Staff Report

**Castle Valley Ranch PA 8 & 9
Sketch Plan
Town Council – November 7th, 2023**

RE: R2 Multi Family Subdivision, Castle Valley Ranch, New Castle, CO – Sketch Plan submission
SE Job # 33011

**RE: Castle Valley Ranch Multifamily – Sketch Plan
R2 Proposal**

**unit type f: 3 bedroom,
2.5 bath
1,400 sf + garage**

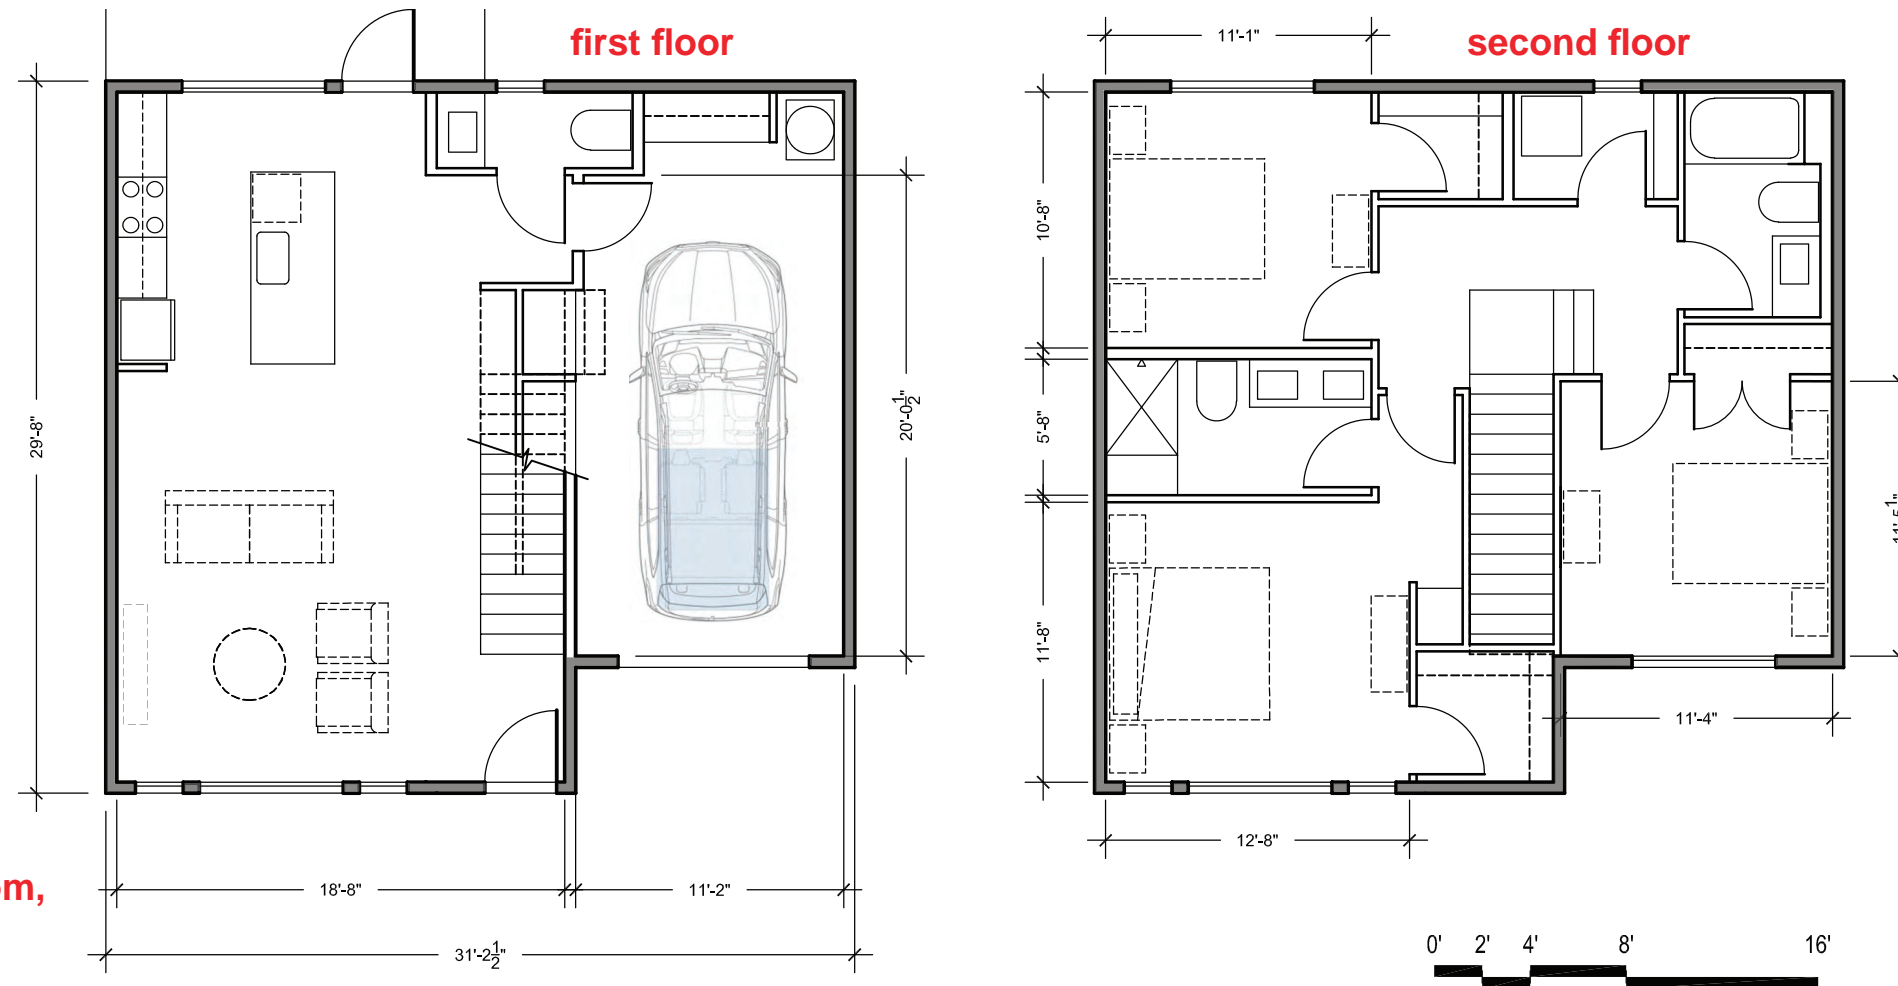
- The mix of unit types and site planning is commendable.
- Provide building heights on plan set.
- 1300-1400sf for three bedroom unit is a tight space. Could be difficult from a livability/practicality perspective.

Illustrative Site Plan

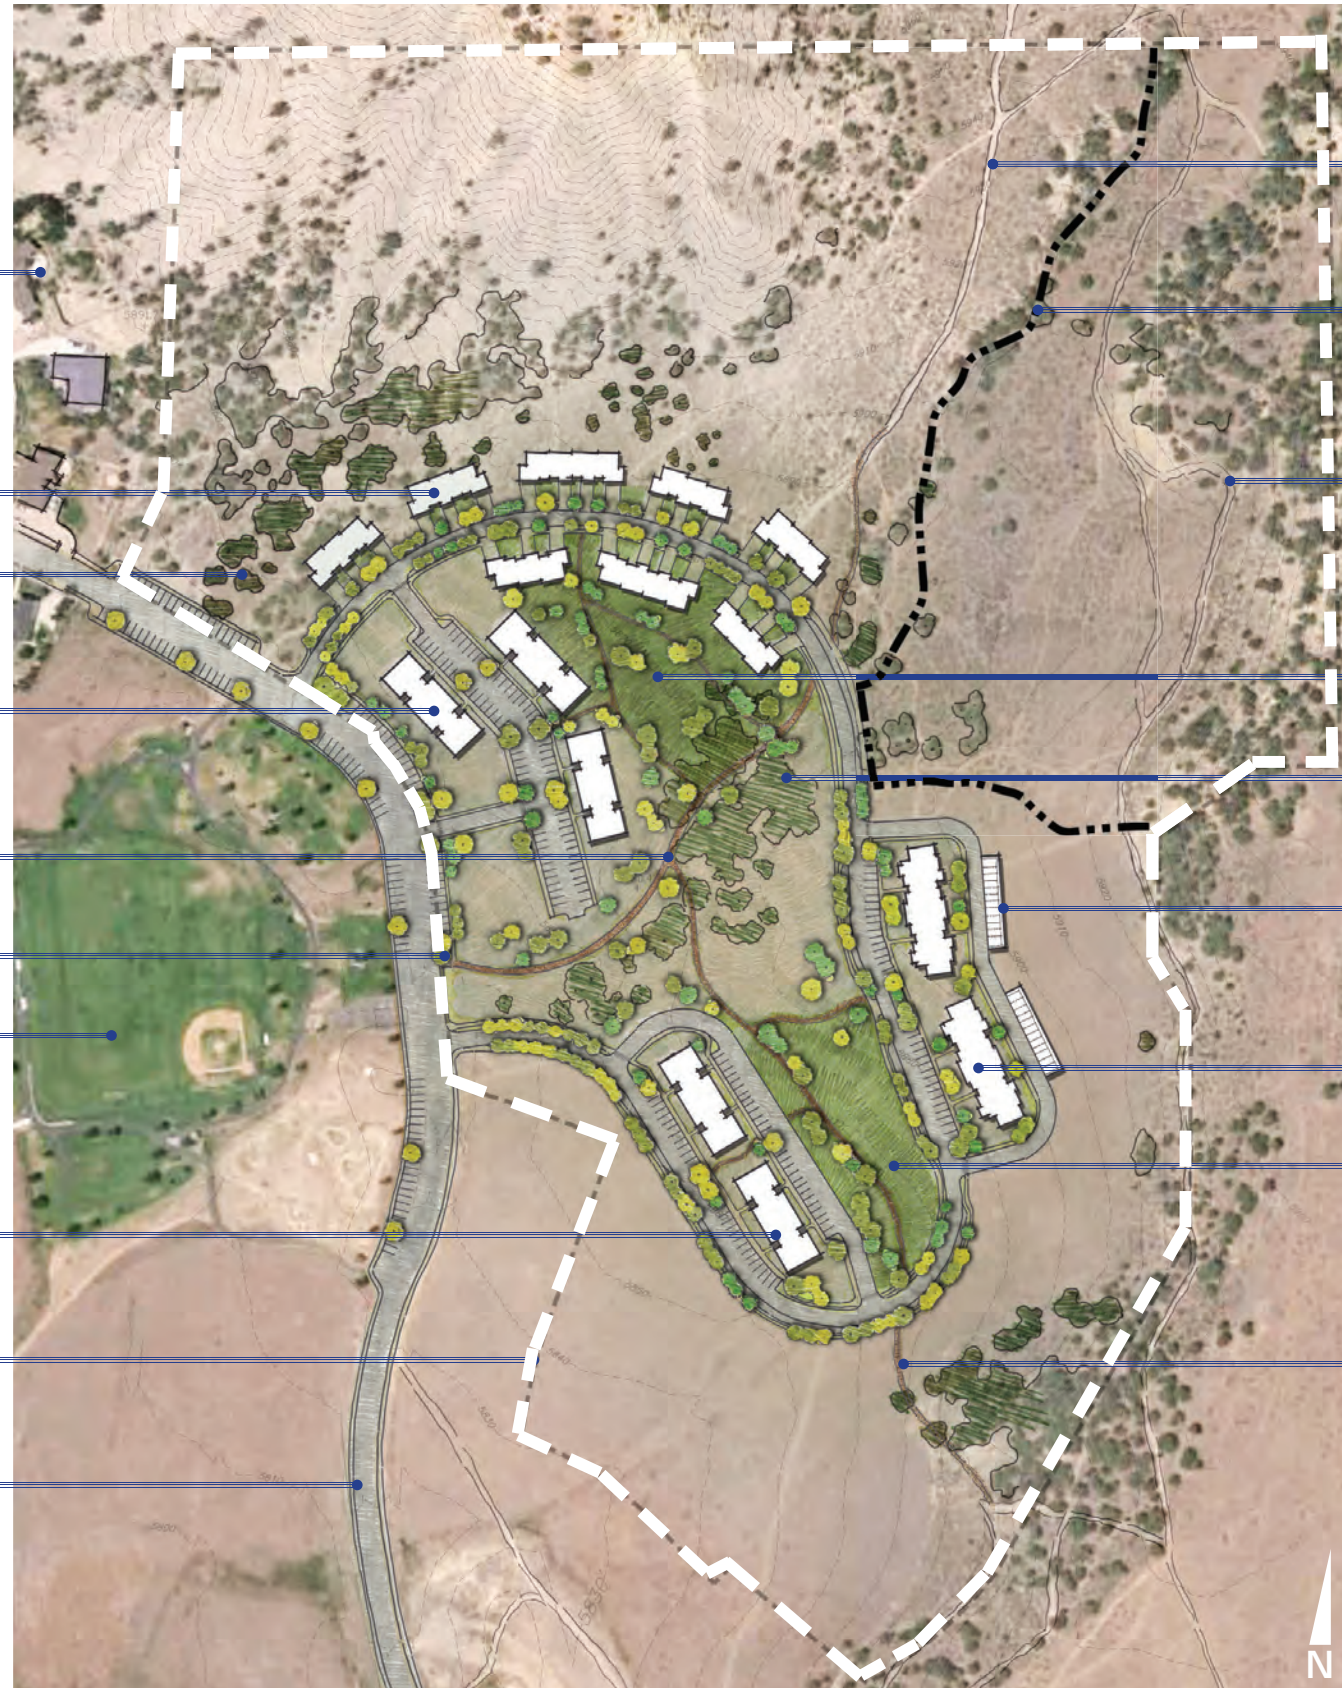
At least two private pocket parks are situated within the interior open space areas. These parks are often underestimated community assets directly adjacent to residential units (**Policy Post-2D**). In these spaces children can explore safely and independently, dogs/owners can go for quick walks after work, and families can picnic together without the hassle of driving.

Open Space: As mentioned, the Applicant has made efforts to integrate existing public use trails and fields into the development’s open space plan (**Exhibit A, page 14**). Small, active parks are provided in two locations interior to the development in both the northern and southern halves. All proposed open space and natural trails, implied as Town wide amenities, should be identified on the plat as Town maintained. Interior trails, pocket parks, or courtyards meant solely for tenant use should be maintained by the HOA.

Typical Right-of-Way Conditions

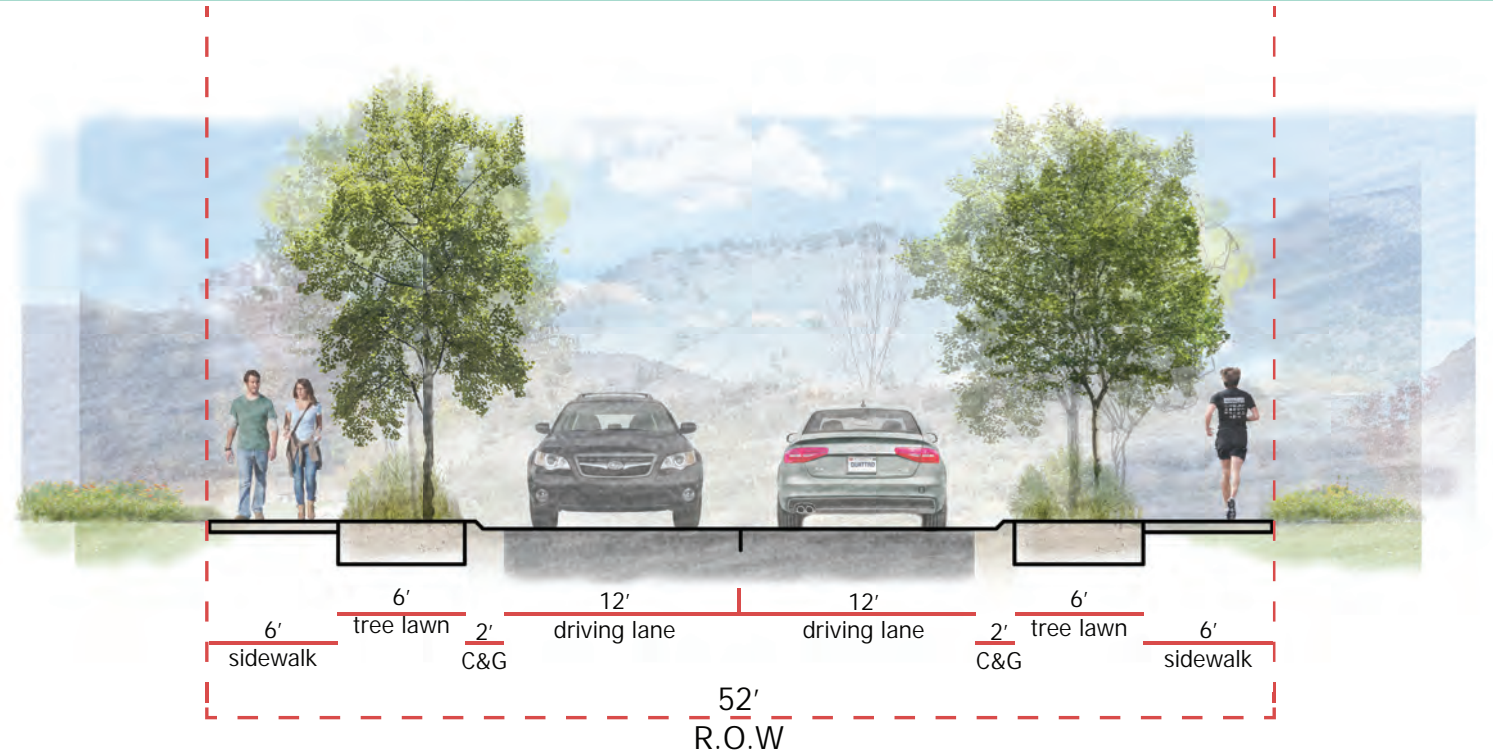
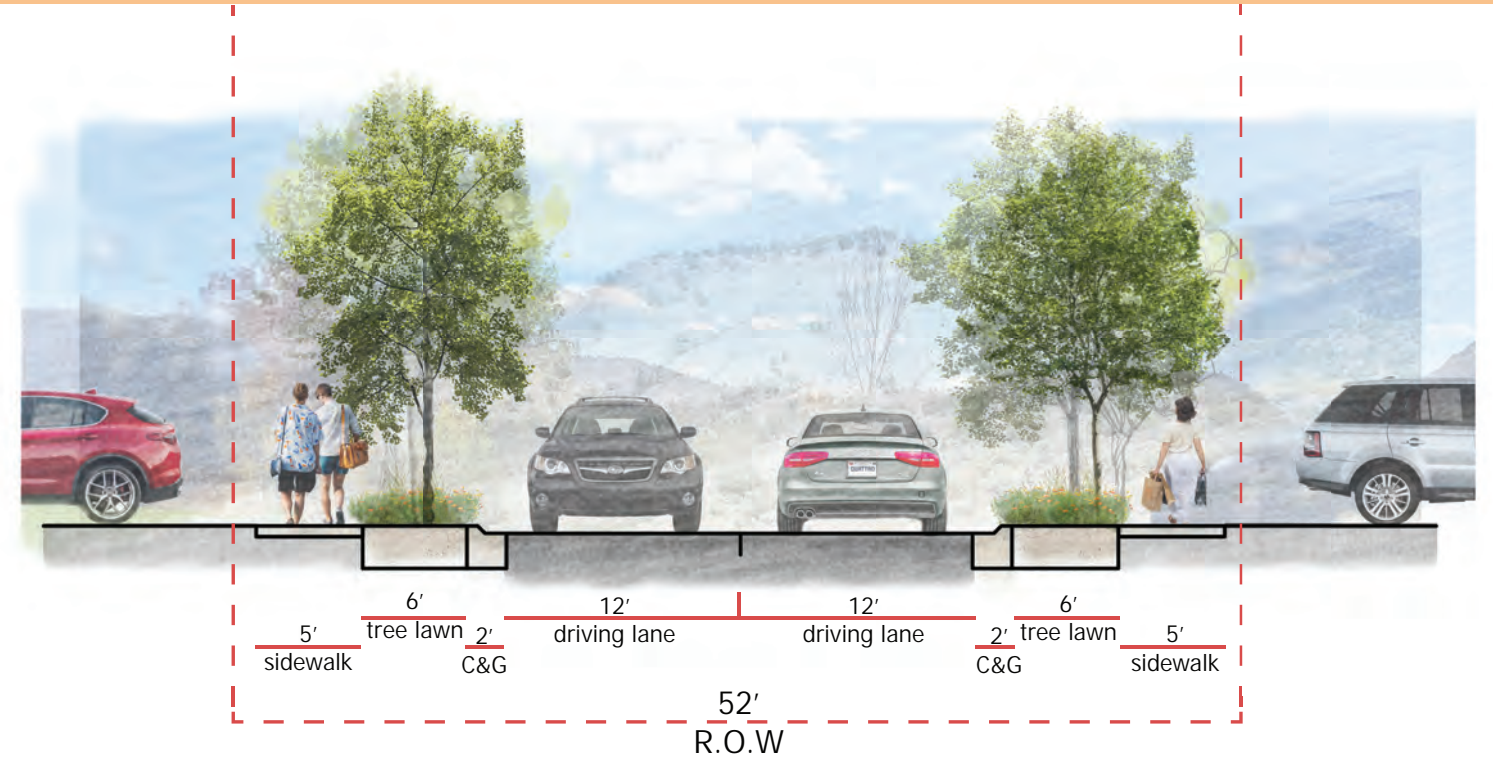
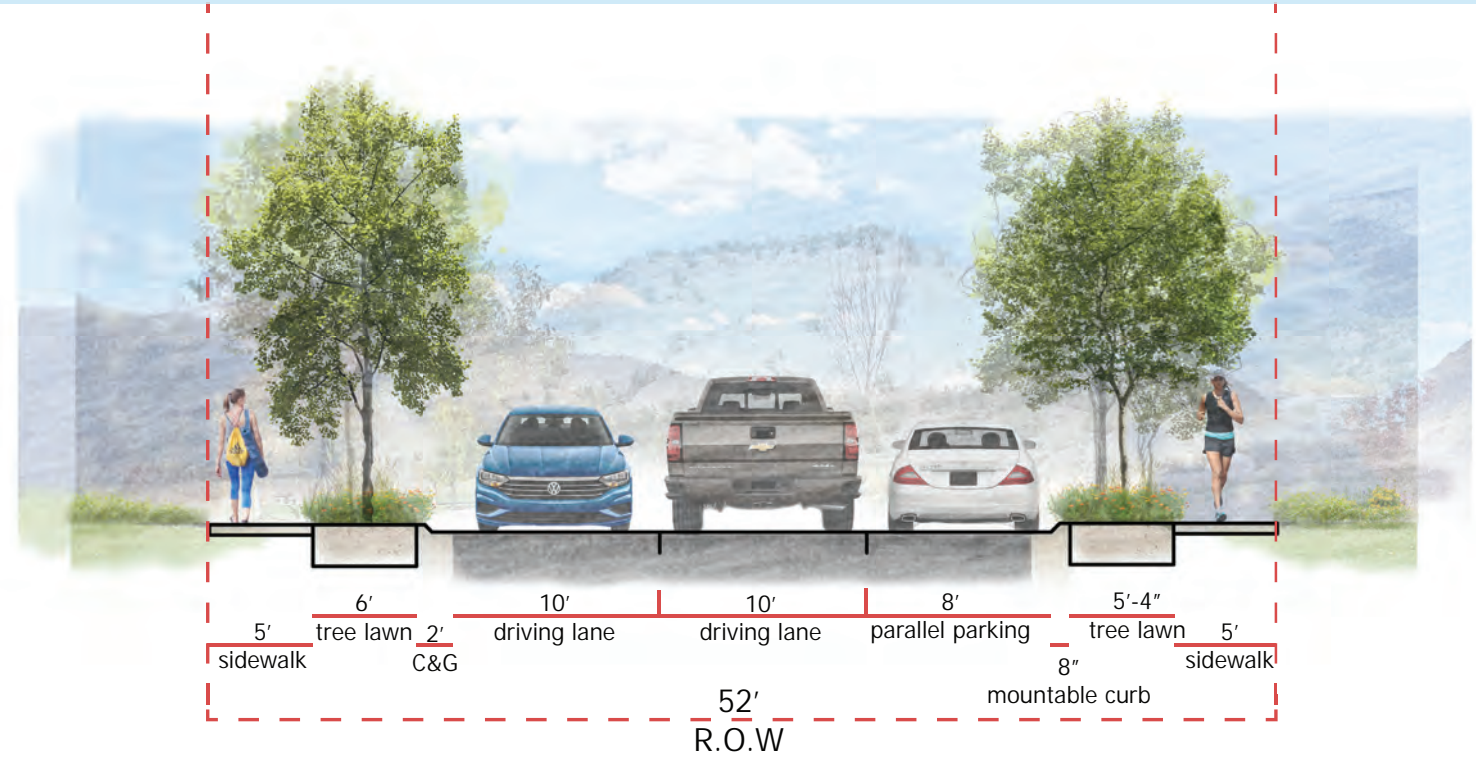
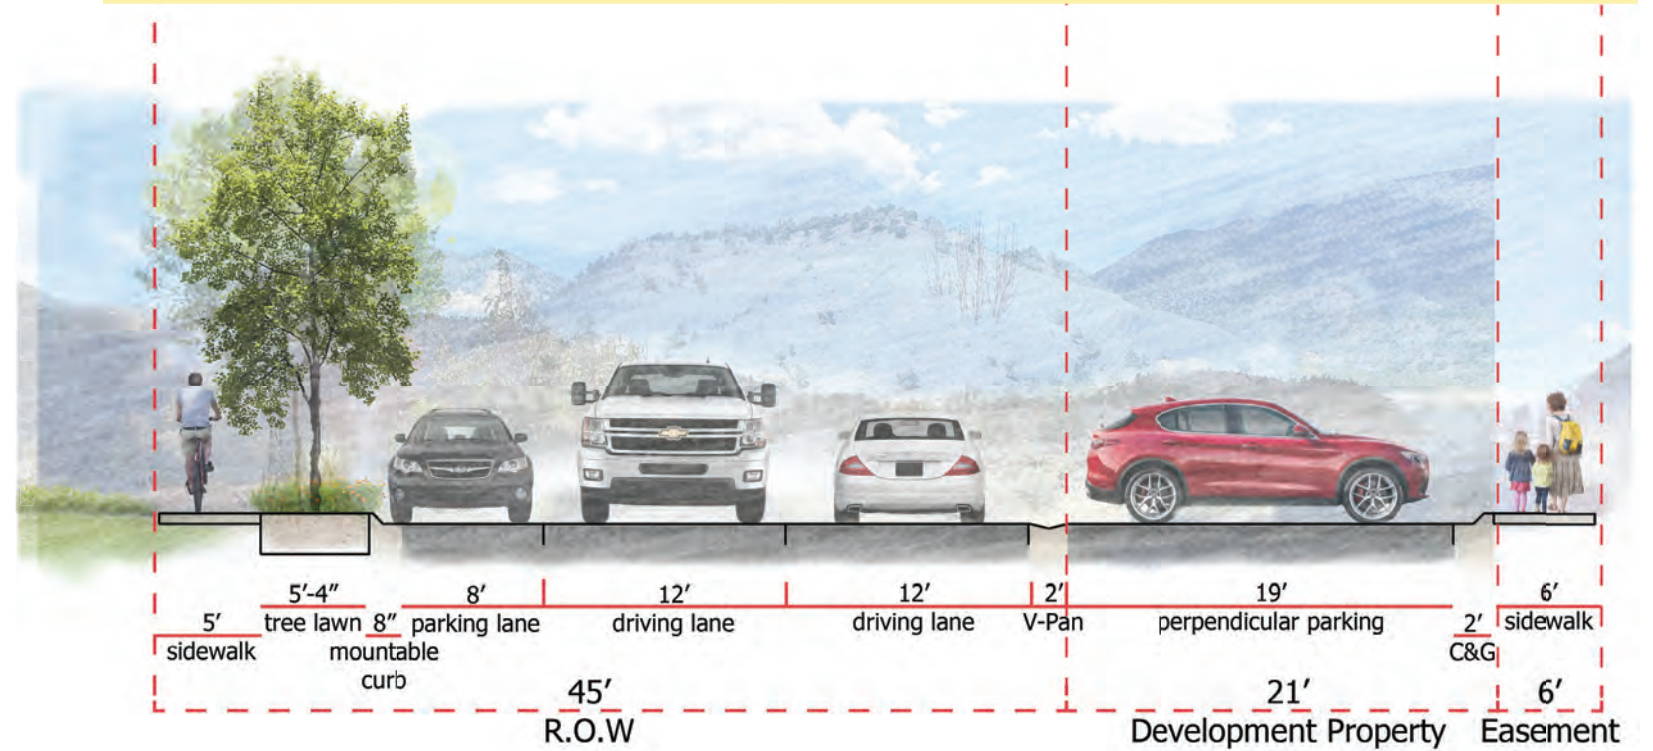
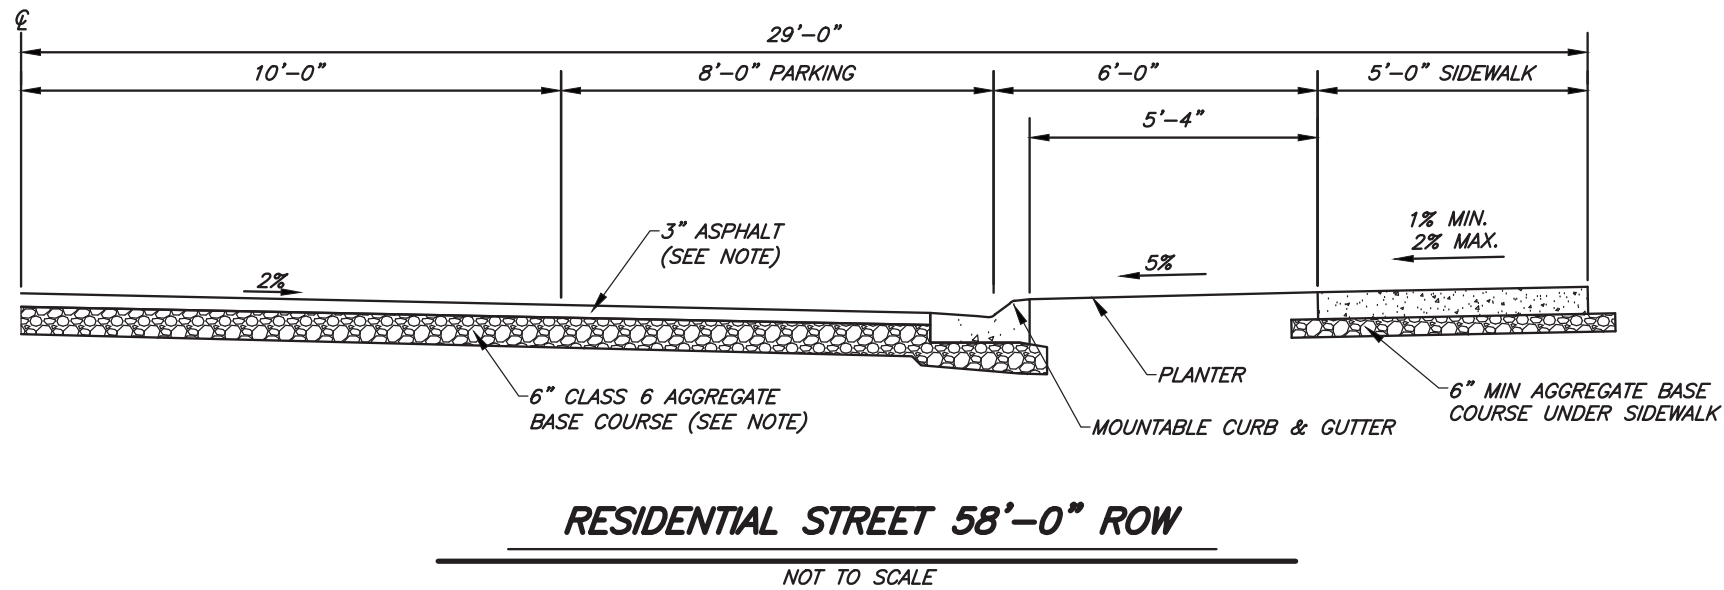
- Why does Staff want a 58' ROW near the townhomes? **Staff response: it provides for better quality of life and was the preferred cross-section for recently approved street design. Residents tend to expect parking on the street in front of homes. Speeding will be addressed with narrower drive and parking lanes.**

- Work hard to make sure roof lines do not exceed ridge lines such as Sunset Trail.
- Provide viewshed image looking from Sunlight Trail back west.
- 52' ROW of ring road should be reconsidered by Staff in order to limit further sprawl.

- A. To better preserve safety, traffic flow, and general quality of life, revise public rights-of-way shown on Exhibit A, page 19 as follows:
 - Teal ROW – no change requested.
